REGULAR MEETING OF THE LAKE ORION PLANNING COMMISSION

Monday, February 5, 2024

TOPIC: PC-23-07 - Peninsula Site Plan Review

Please see the attached revised site plan documents addressing the review comments from Nowak and Fraus's review letter dated December 14, 2023, Orion Township Fire Department review letter dated December 18, 2023, and Mckenna review letter dated December 19, 2023 (responses are *italicized*):

Date:	01.04.2024
Scale:	1" = 20'
Sheet:	4 of 4
Project:	20107.35

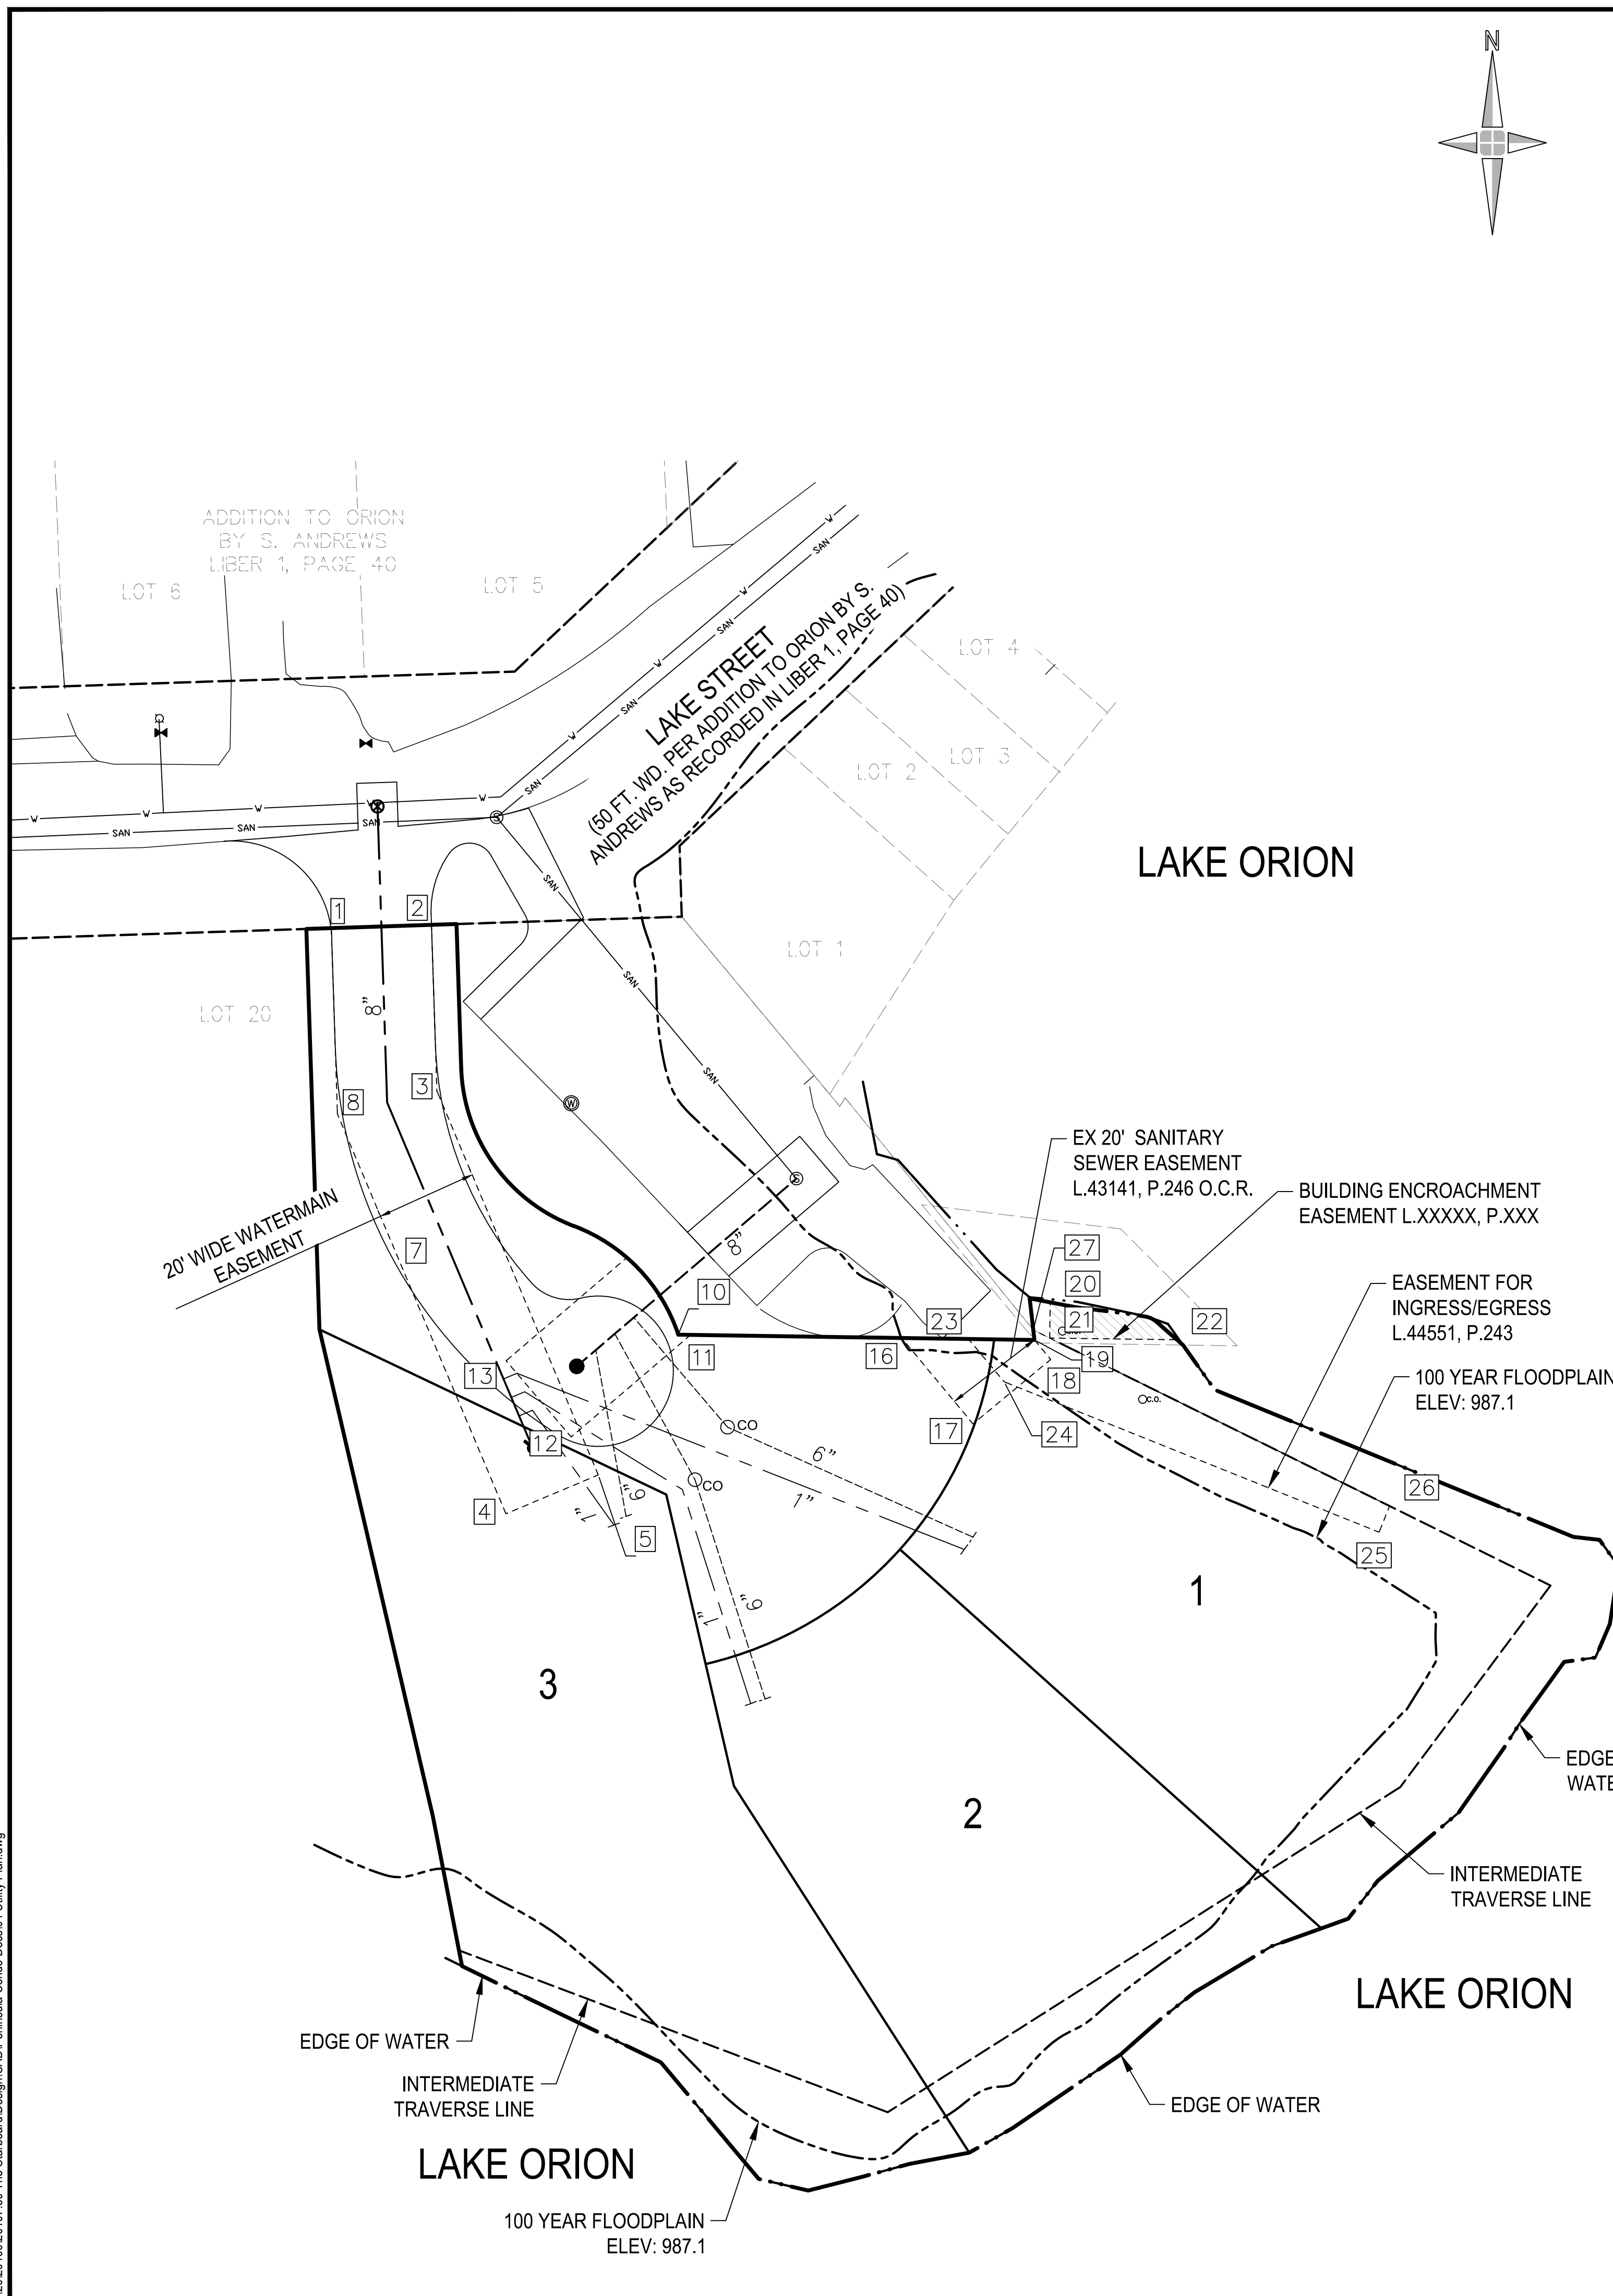
10. Utility service leads are shown but not labeled on the Utility and Easement Plan.
11. Note 3 on sheet 4 of 4 refers to Oakland Township. Correct the reference.

1. The Master Deed has been revised to address our previous review comments.
2. We note sheet 4 of 4 still includes “The” in the project name. Final condominium plans must show a consistent project name.
3. Applicant has acknowledged that a LOMR-F is required to reflect the proposed revised floodplain contour. This will be done after construction.
